Comment Regarding the GMUG Forest Plan Update

Marcus Trusty
President, Colorado Offroad Enterprise (CORE)
November 24, 2021

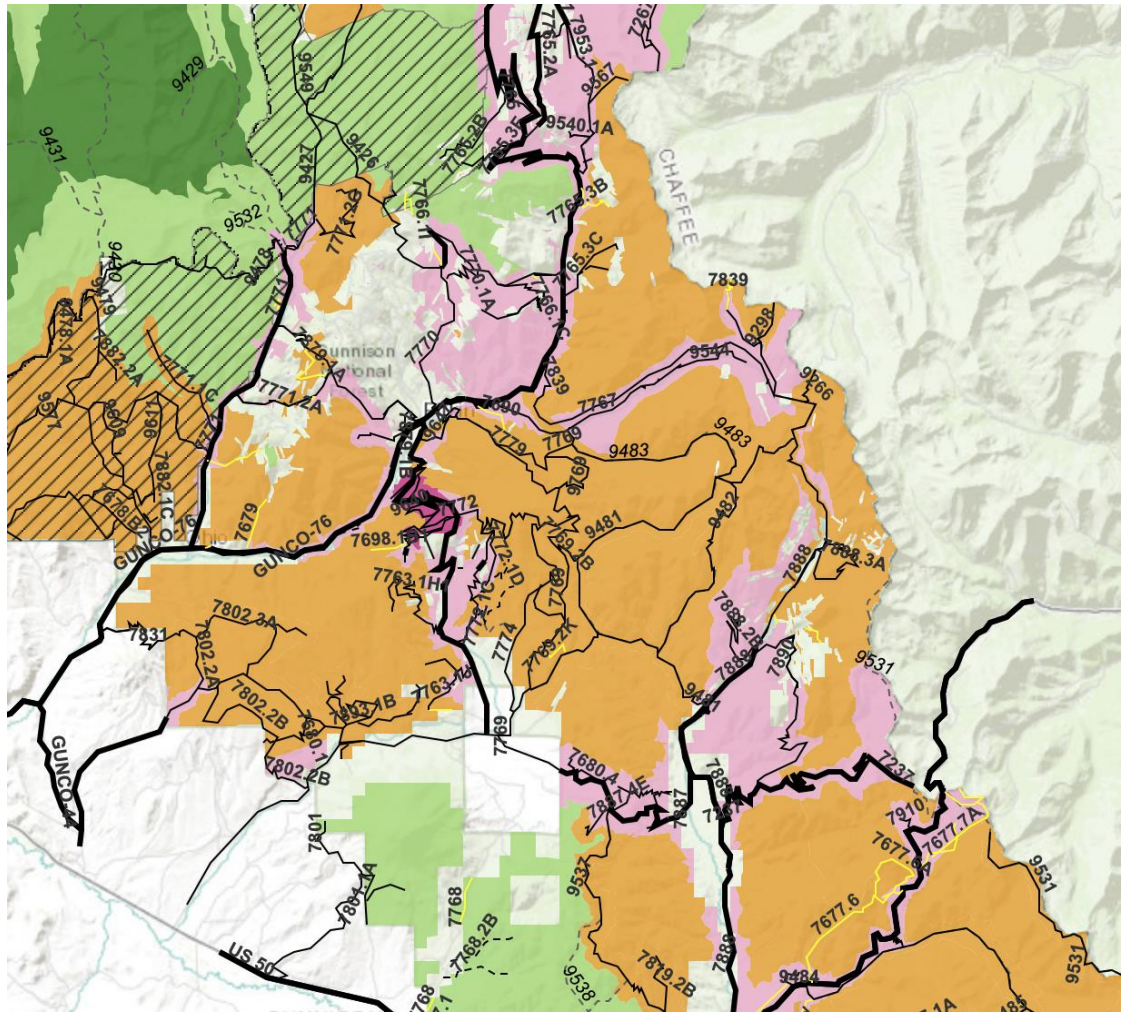
Alternative B has some errors with non-motorized ROS zones overlaid with existing motorized routes. Still, our biggest concern is that the ROS zones for motorized routes are mainly non-existent. The GMUG planning team chose to place motorized zones around existing routes in a cherry stem manner, establishing non-motorized or other zones outside these motorized buffers.

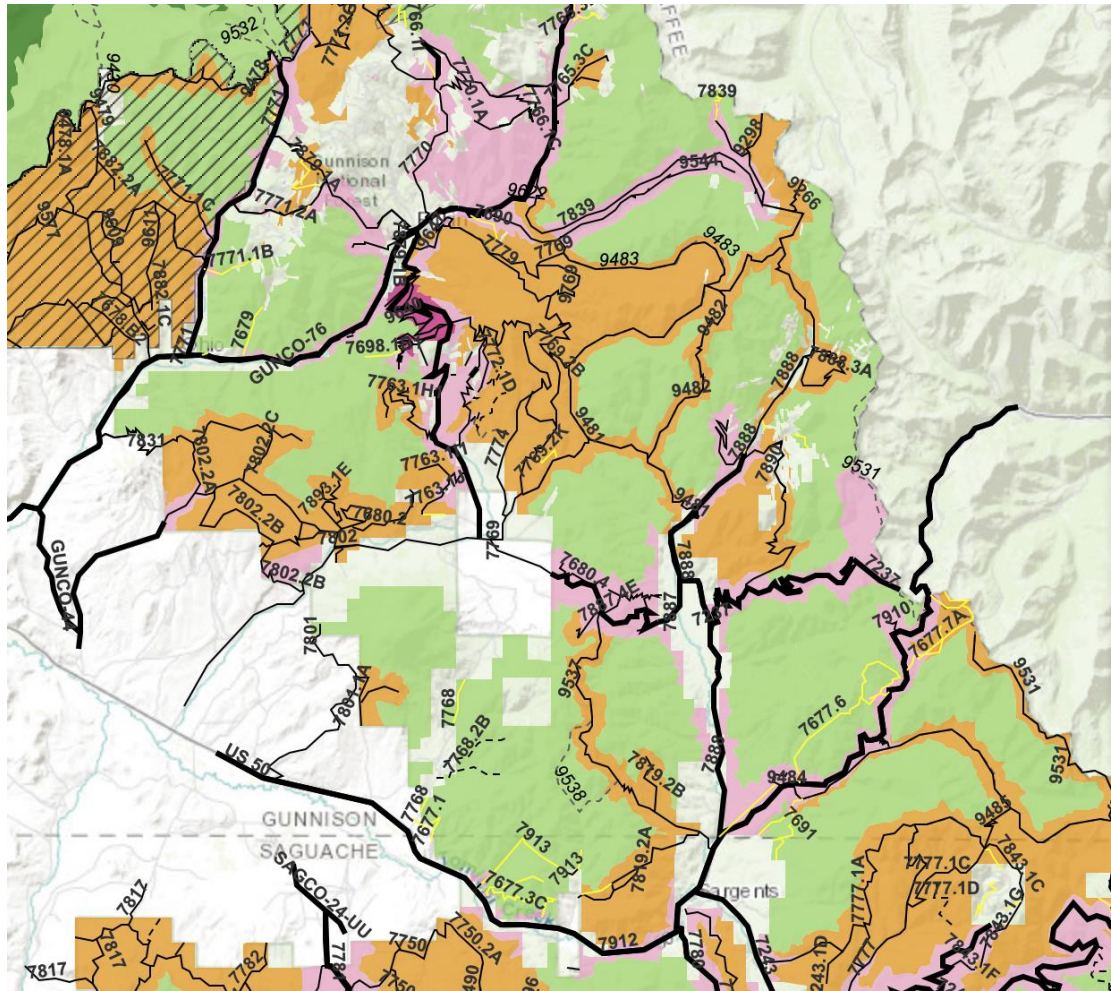
We recommend Alternative C for several reasons: the importance of maintaining the existing ROS zones for semi-primitive motorized recreation. These zones keep existing motorized roads and trails intact and allow future area management in expansion, re-routes, or route replacement. A great example of this can be found between the towns of Whitepine and Pitkin. From the below picture, Alternative C places the entire area in the light brown Semi-Primitive Motorized Zone (SPM) zone, similar to the 1983 Forest Plan Map.

It is imperative to keep these motorized ROS zones intact to manage for the future. We have adopted Tomichi Pass (888), Hancock Pass (266), Alpine Tunnel (544), and help with Williams Pass (298). The area has experienced environmental events rendering some of these routes closed for extended periods in the past. We have done work on Tomichi Pass (888), Williams Pass (298), and Alpine Tunnel Road (544) to reopen the routes for public use. GMUG Planners cannot predict future environmental events and which motorized route challenges will be present in the future. If these routes are simply cherry stemmed as in Alternative B, there is not much margin for error. See the corresponding photo below depicting Alternative B for the same area.

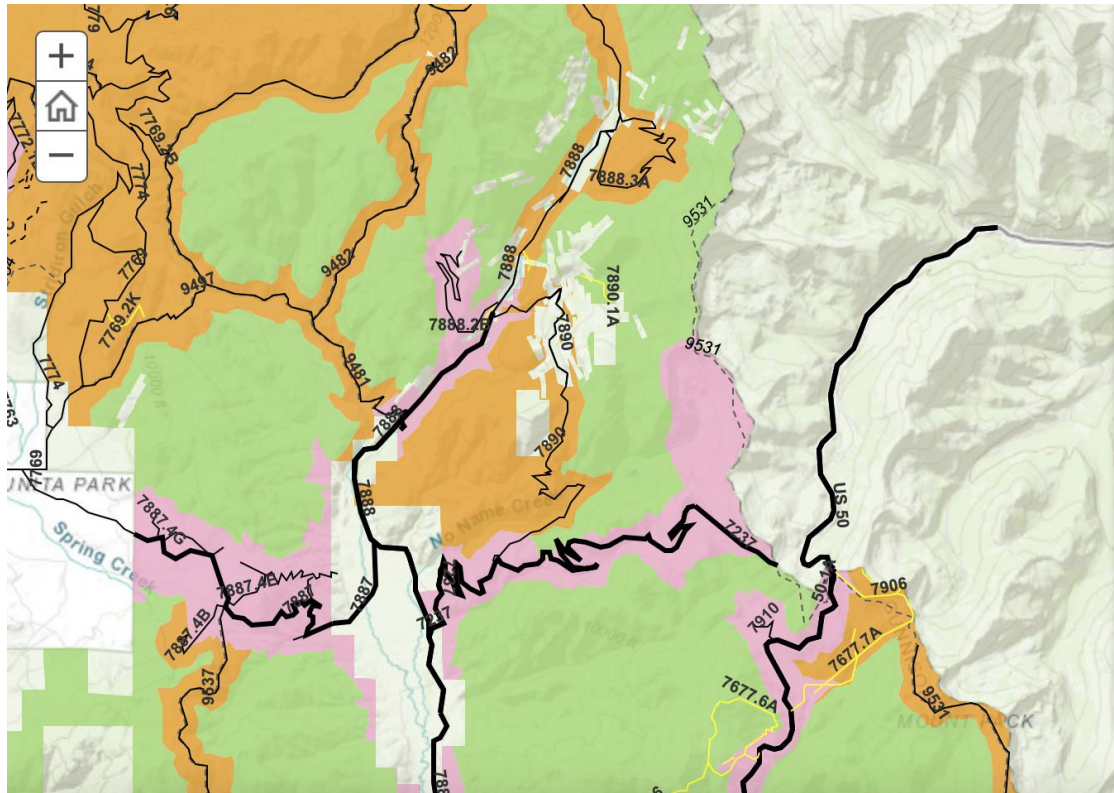
Another important example in this area GMUG Planners need to consider is the issue facing NFSR 890 just south of Whitepine. NFSR 890 once connected the Whitepine area with the Old Monarch Pass Route (237). Several years ago, Gunnison County claimed right-of-way on 890, keeping it open to public use, but then abandoned their claim turning the management of 890 over to property owners along the route. One property owner has since gated the road. This removed public access and severed connectivity to 237.

One option is to re-route 890 or to build a new trail connecting Whitepine to 237. If a motorized ROS zone is not maintained in this area, and on both sides of 890, there will be no possibility to explore a solution to this problem. The screenshot above shows NFSR 890 above in Alternative B. The 1983 2A SPM zone has been shrunk down, and now a SPNM zone occupies everything east of NFSR 890. On the flip side, Alternative C is the best option because it would keep most all the SPM zone fully intact for this area.
